Type: Bulletin

Title: B-pillar applique Fastener updates

Applicability: MY2025 Revero, GS-6, Revero GT and GTS

PURPOSE: Update fasteners as a field fix

Used in 2 positions per side

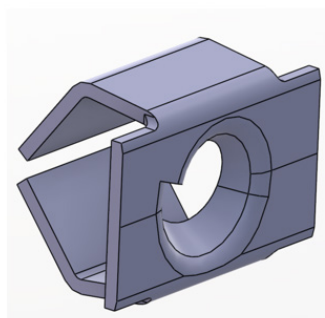
NEW

C144830407200 – Push Nut, provides better retention and fitment of B–Pillar Applique

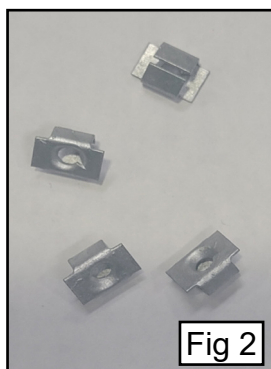
Remove the B-pillar applique (Fig 1). The passenger (right) side will disassemble and reassemble same as the driver (left side shown). Retain any plastic washers used in previous assembly.

Note: Additional plastic washers can be used as shims to achieve flushness to door glass. Do not exceed two washers per fastener.

Remove the installed push nuts, and replace with C144830407200 push nuts (Fig 2). Reassembly torque for the b-pillar fastener screws is 2.5 +/-0.5Nm (T20 size in Fig 3).

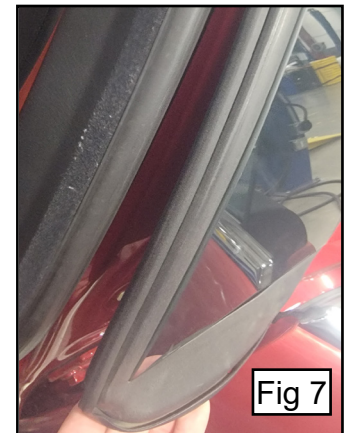
Open both doors to access the seal bottom, pull it up to reveal T20 screws (Fig 4). Remove the fasteners (Fig 5 and Fig 6), and pull up gently and the top clip will release (Fig 7).

Note: watch for any plastic shims that may fall, you will reuse these to maintain established fitment.

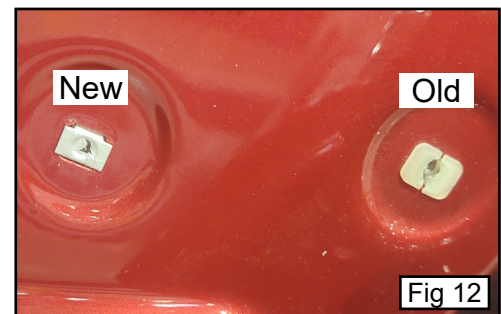
Remove the old in body clips (Fig 8).

Use a small pick tool to catch the inside of the clip and wiggle it out (Fig 8 and Fig 9).

Insert the new clips (these are very small Fig 10, and Fig 11, Fig 12)

Using a shim to apply pressure to the clip to pop it in place is helpful.

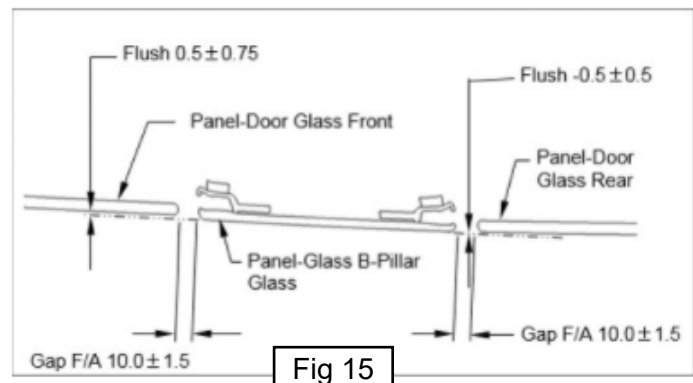
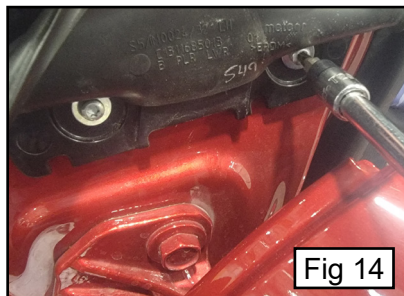
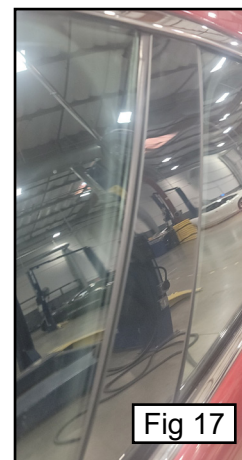
Hold the B-pillar applique in place and align the screws to the new clips, and place washers behind on the screw as it is assembled, do not tighten one side fully until both are holding plastic shims. Once seated, begin to tighten down, and press in the upper part of the applique so it snaps the clip into the upper b - pillar (Fig 13). Proceed to torque the screws to the appropriate measurement in Fig 14 (2.5 +/- 0.5Nm) Check flushness to the door glass as below (Fig 15).

The b-pillar should now sit as flush as specification with minimal adjustment expected. (Fig 16 and Fig 17)
